SUBMITTAL SUMMARY REPORT MasterPlan-000673-2026

PLAN NAME: Oak Shores Estates	LOCATION: 0
APPLICATION DATE: 04/23/2026	PARCEL: 9064-0000-02
DESCRIPTION: Oak Shores Estates

SUBMITTAL	STARTED	DUE	COMPLETE	STATUS
OCE: Plan Review (DR) v.2	06/03/2026	06/10/2026	06/15/2026	Approved
OCE: Plan Review (DR) v.1	04/24/2026	05/08/2026	05/18/2026	Requires Re-submit

SH. 06.01

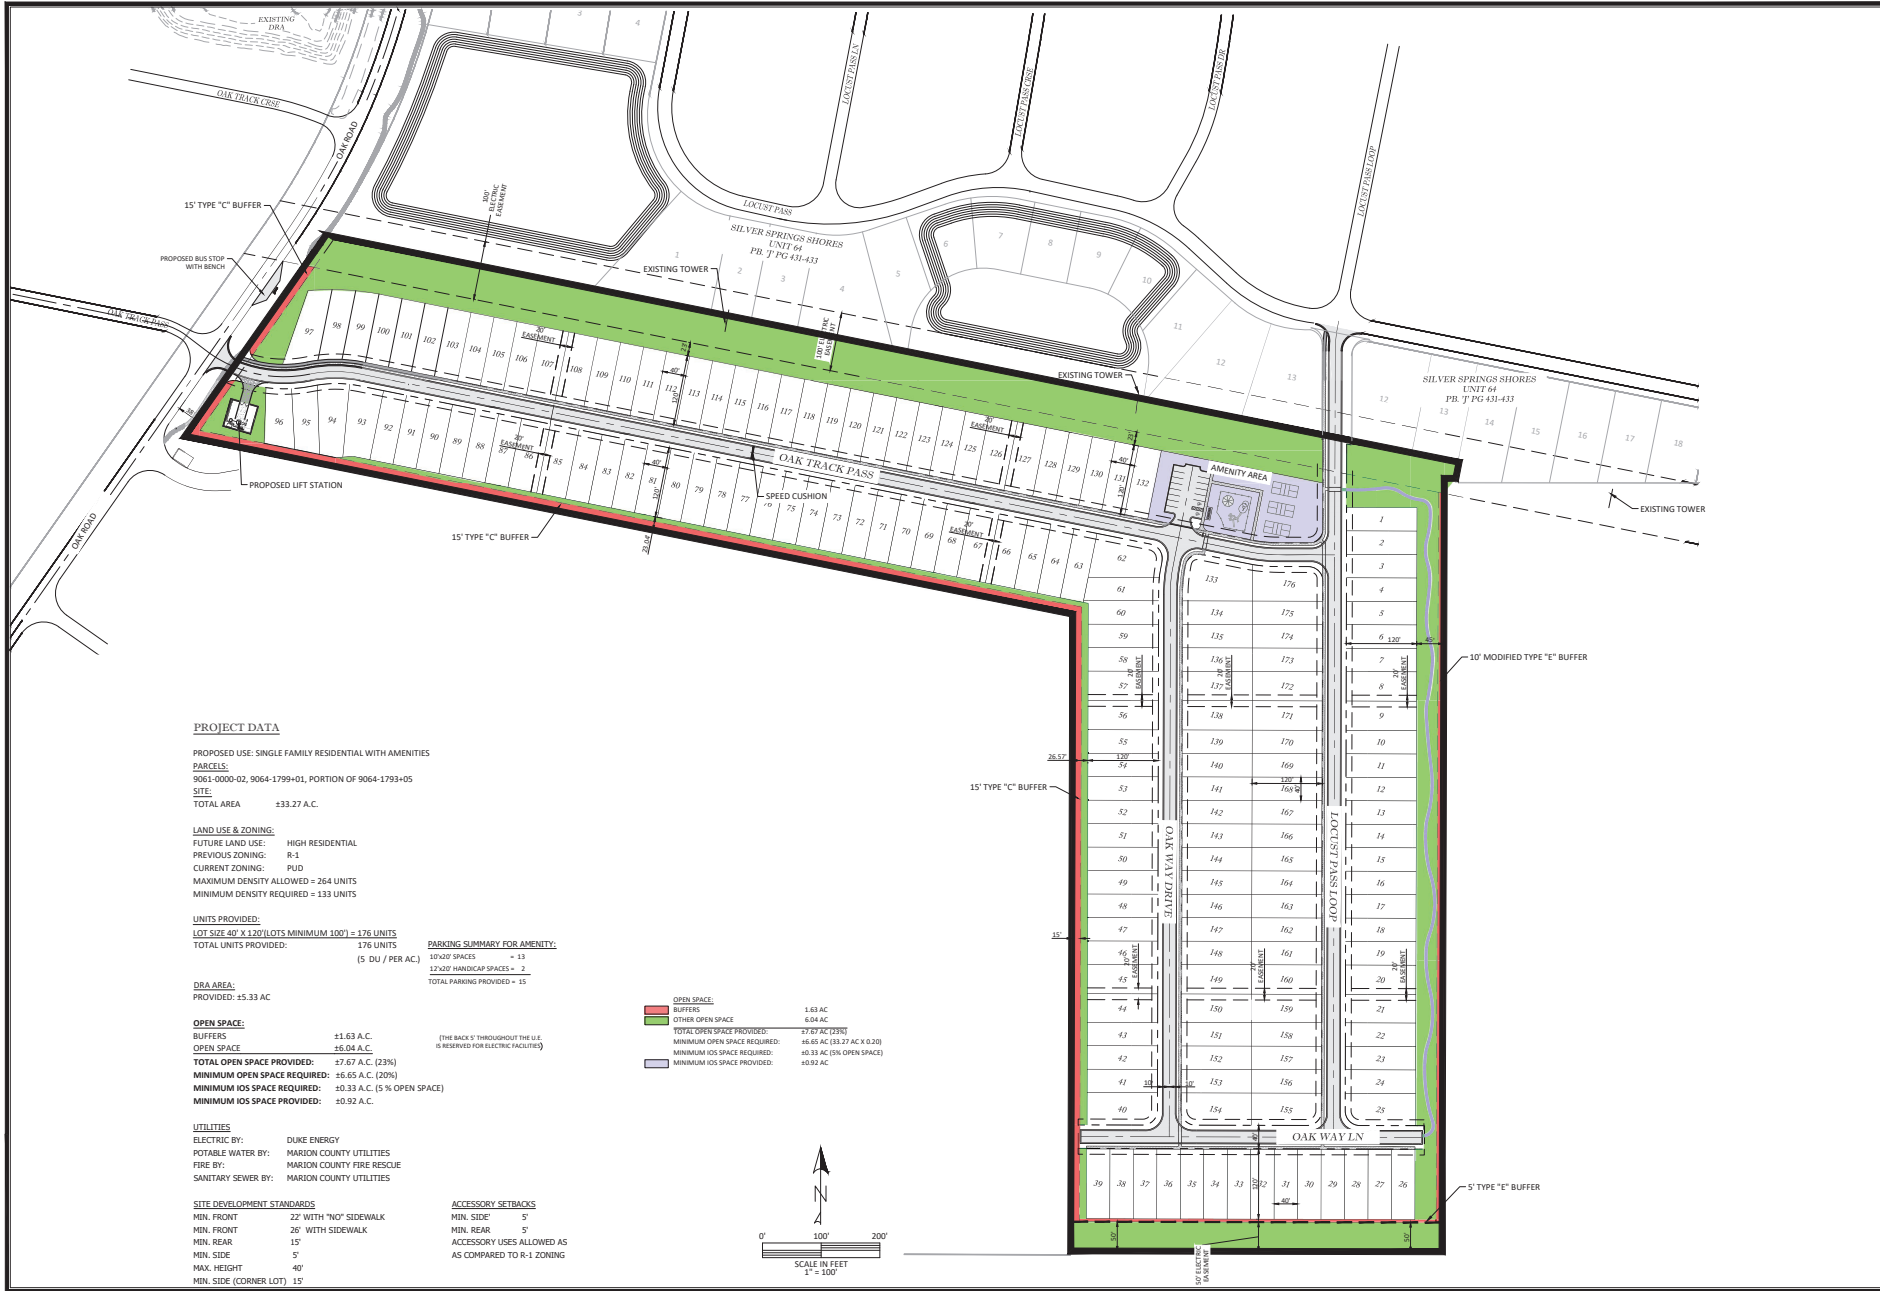
Sheet 06.01 - Roads have been named on this sheet. Please update on all applicable sheets on all future submittals.

<i>Corrections</i>	4.2.31.E&F/6.8.6 - Buffering (Not Resolved) - Corrective Action: Revise "Table 3.B Buffers" on cover sheet. East buffer to vacant residential, agricultural production, and single family residential was approved as modified 10' E-Type. The correct buffer is shown on Sheet 06.01 and 09.01. - 4.2.31.E&F/6.8.6 - Buffering: Show buffer types, locations, and dimensions of required buffering on plan. Show buffer descriptions and illustrations of each proposed buffer (including longitudinal and transverse cross-sections)			
<i>Corrections</i>	4.2.31.F - Phases of development (Not Resolved) - Corrective Action: Note 1 on cover sheet indicates that developer may develop the project in multiple phases. Master plans are required to show phasing per LDC Sec. 2.11.1. LDC Sec. 2.12.20 requires that improvements must be in place to support each phase of development at time of phase completion. If phased development for homes occurs, it is not clear how DRAs, buffers, and amenities will be phased. Phasing needs be shown to demonstrate compliance with the approved resolution, specifically conditions 2 and 3. - 4.2.31.F - Phases of development: Show all phases of development on plan. Improvements must be in place to support each phase of development at time of phase completion.

sh. 08.01

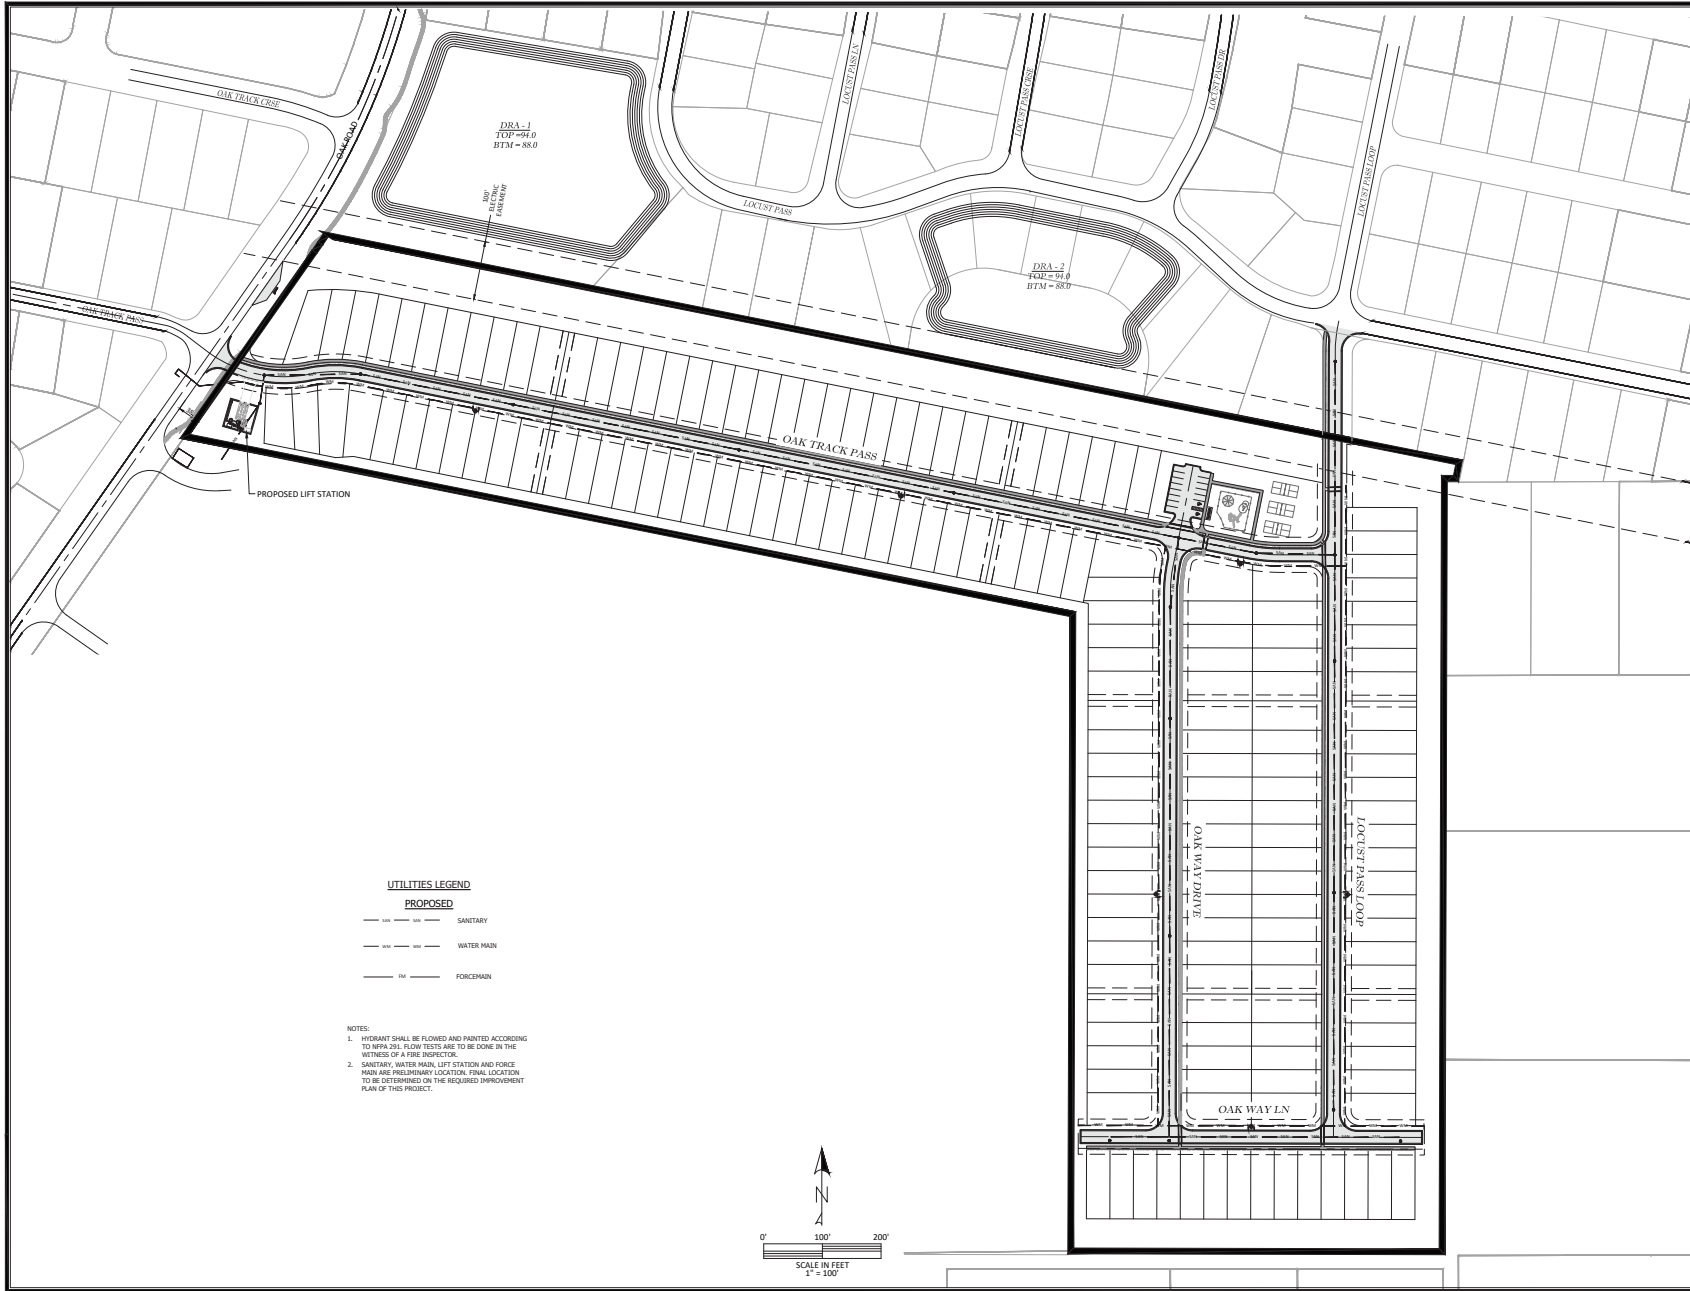
Utilities (OCE Plans) (Utilities)	Heather Proctor	05/08/2026	05/04/2026	Informational
Comments	Please see plan mark ups regarding lift station.

Erik Kramer	Correct reference is 26-S02	05/01/2026 3:40	PM_Combined Plans.pdf	1
Heather Proctor	Suggestion: If possible, re orientate the station to access from Oak Rd. Relocate the bus stop to remove conflict wit station driveway.	05/04/2026 9:38	AM_Combined Plans.pdf	6
Erik Kramer	Why was this language added? 26' setback and 22' setbacks based on presence of sidewalk was not discussed or approved during PUD rezoning process. Please remove Section 24. This is only in Section 23.	05/05/2026 10:21	AM_Combined Plans.pdf	3
Kristie W		05/05/2026 3:58	PM_Combined Plans.pdf	1
Kristie W	Should be 23	05/05/2026 3:59	PM_Combined Plans.pdf	1
Kristie W	9-1-1 REQUIRES RESUBMIT	05/05/2026 4:04	PM_Combined Plans.pdf	1
Kristie W	OAK TRACK PASS	05/05/2026 4:10	PM_Combined Plans.pdf	6
Kristie W	LOCUST PASS LOOP	05/05/2026 4:12	PM_Combined Plans.pdf	6
Kristie W	OAK WAY DRIVE	05/05/2026 4:13	PM_Combined Plans.pdf	6
